NRC RAI Letter No. PTN-RAI-LTR-040

SRP Section: 02.05.04 - Stability of Subsurface Materials and Foundations

NRC RAI Number: 02.05.04-1 (eRAI 6006)

Figure 1. Line 10 Geophysical Data

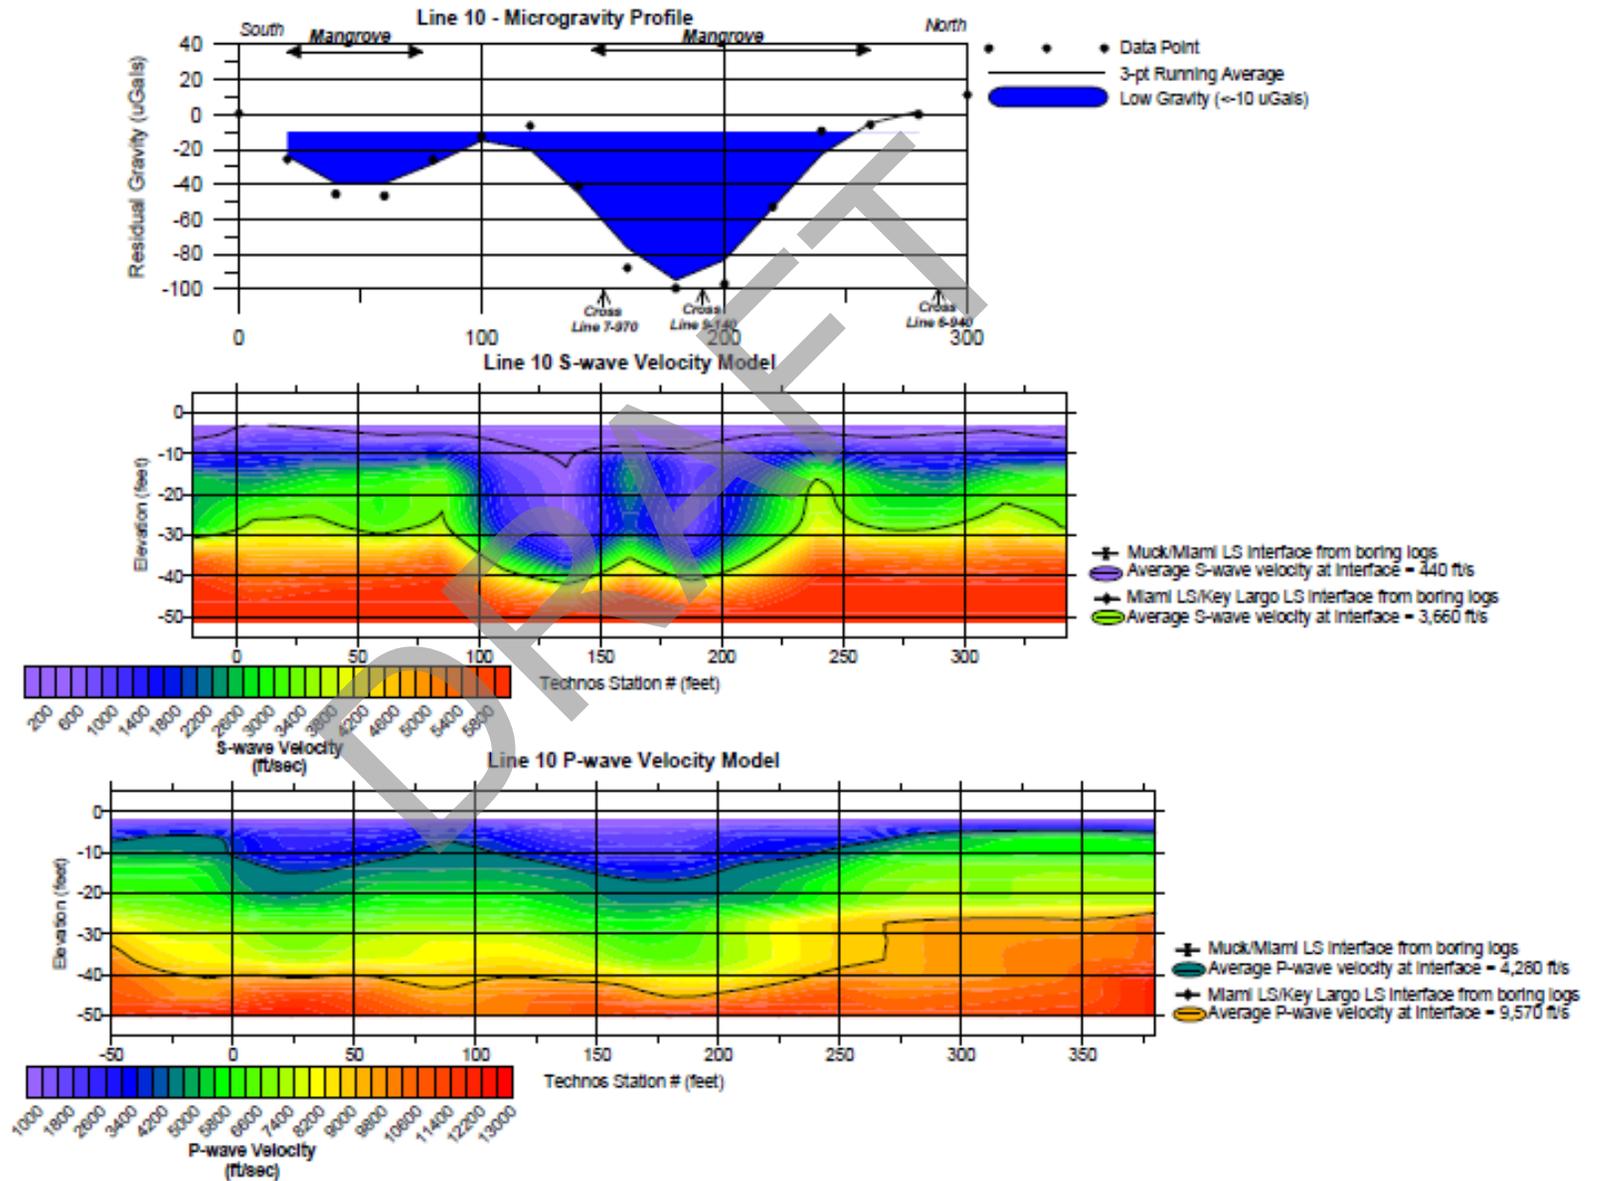
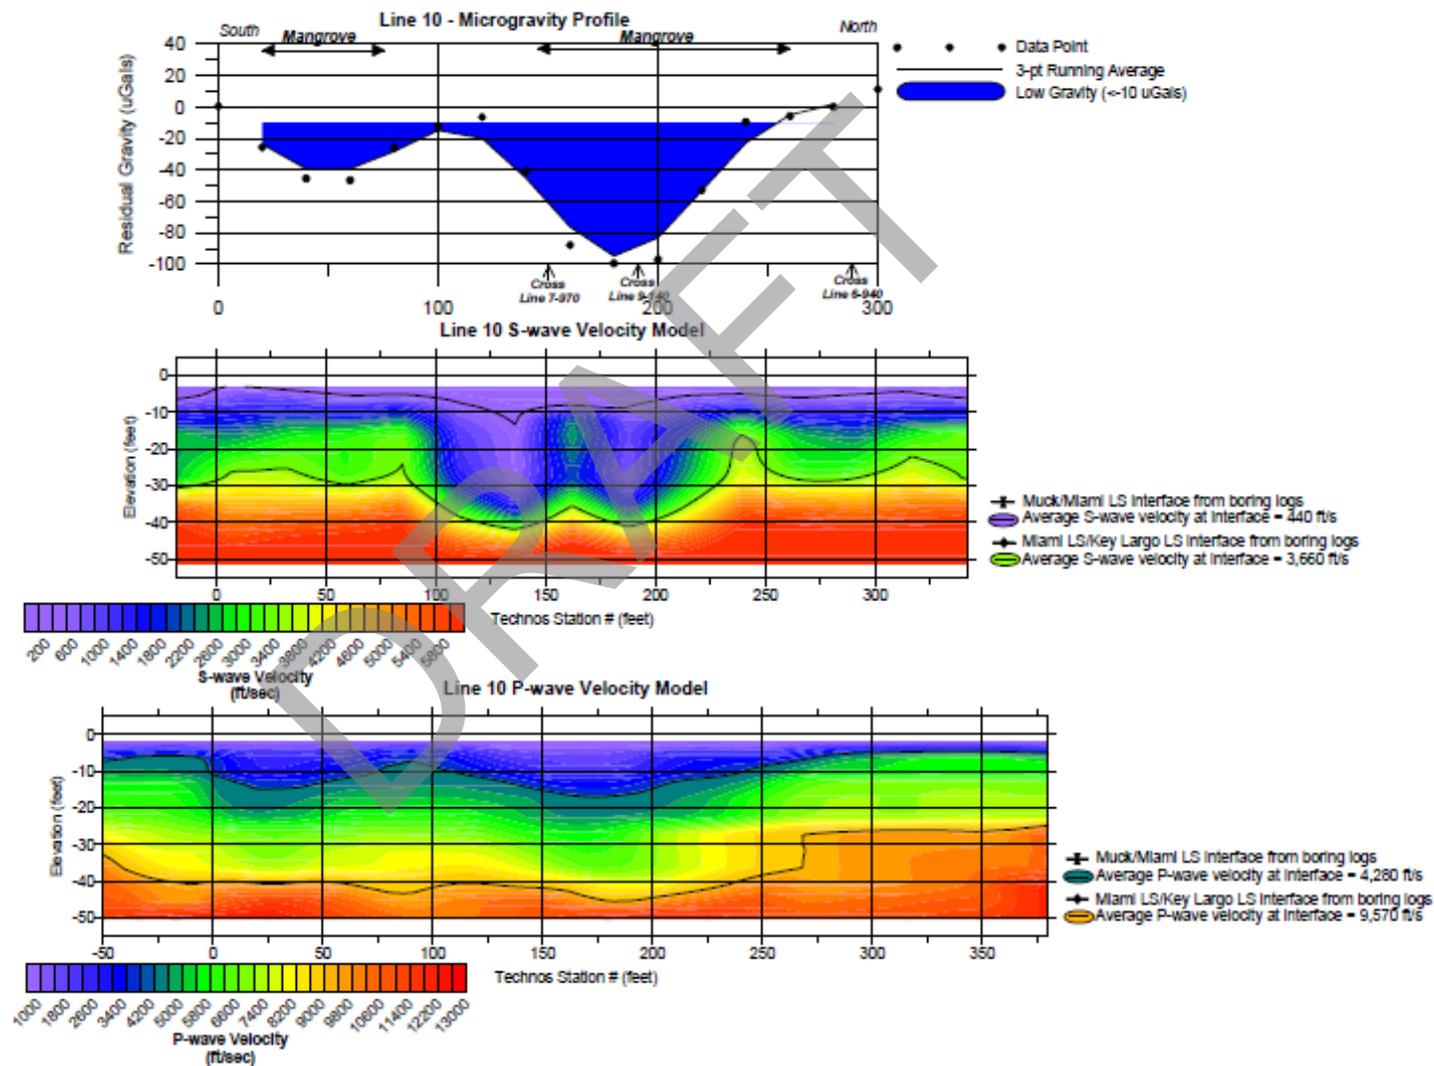
FSAR Section 2.5.4.1.2.1 presents a discussion on dissolution activity in the limestone formation, including potential cavities at depths. Among the data sets used to assess the potential existence of cavities is the microgravity data presented in Figures 2.5.4-224 through 231 which provide insights into the existence of potential cavities in at the site. Based on the analysis of gravity data analyses, this section concludes that there are no large cavities underneath the site. In accordance with NUREG-0800, Standard Review Plan, Chapter 2.5.4, "Stability of Subsurface Materials and Foundations," and Regulatory Guide (RG) 1.132, "Site Investigations for Foundations of Nuclear Power Plants" please provide additional discussion on the adequacy of the assumptions used in the microgravity data analyses. Since only profile measurements were made and large gaps remain between profiles throughout the site area, please justify your assumption that no large cavities exist throughout the site. Also, please provide additional references and data sources used to reach this conclusion.

The assumptions used in the microgravity data analysis include assuming that a spherical, water-filled cavity would have a sufficient density contrast with the surrounding limestone to produce a microgravity anomaly. The density contrast is based on laboratory test and published data summarized in the FSAR Subsection 2.5.4.4.5.4 and on experience conducting similar geophysical surveys in south Florida. A spherical cavity was used in the analysis as the most conservative approach since it represents the most compact form of "missing mass," and therefore produces the smallest gravity anomaly for a given cavity diameter. Other geometric distributions of a cavity, having the same diameter as the sphere, would produce a significantly larger gravity anomaly. The detectability of the anomaly varies with cavity size, depth, and location with respect to the survey line.

To further reduce any uncertainties in the resolution and interpretation of microgravity data with depth, and away from geophysical survey lines and boreholes, FPL proposes a commitment to conduct a microgravity survey on the base of the nuclear island (NI) excavation. The current excavation concept is to grout the excavation as part of the dewatering program. FSAR Subsection 2.5.4.5.4 describes the dewatering and excavation methods. The installation of a grout plug, approximately 25 feet thick, to prevent vertical seepage is described in FSAR Subsection 2.5.4.6.2 and, in more detail, in ER Subsection 3.9.1.7. The grout plug will be constructed from elevation -35 feet NAVD 88 to elevation -60 feet NAVD 88 by first drilling from the ground surface and then grouting. Vertical boreholes will be drilled in a grid pattern and grouted in an iterative process, which is estimated to consist of four rounds of drilling and grouting, prior to excavation. The grouting procedure described in ER Subsection 3.9.1.7 is expected to fill voids that may exist beneath the nuclear island excavation to an elevation of -60 feet NAVD 88. It is anticipated that the density of the grout will be similar to that of the foundation limestone and that the proposed microgravity survey will be designed to detect density anomalies below the grout plug that represent potential solution features with a diameter of 25 feet or greater if spherical and 12 feet or greater if cylindrical. Preliminary estimates indicate that a hypothetical solution feature with an approximate diameter of 30 feet at a depth immediately below El. -60 feet NAVD 88 will have a negligible effect on the stability of the nuclear island foundation, i.e., negligible effect on bearing capacity, settlement, or resistance to sliding. Such a cavity would cause an increase in stress levels in the vicinity of the cavity due to stress redistribution. However, the stresses from the design loading on the nuclear island at that depth are comparatively low (less than 50 psi) so that the effects are insignificant in the limestone of the Fort Thompson Formation with an average unconfined compressive strength of 2,000 psi (FSAR Table 2.5.4-209).

Figure 2.5.4-241 will be added to FSAR Subsection 2.5.4 in a future COLA revision:

Figure 2.5.4-241. Line 10 Geophysical Data
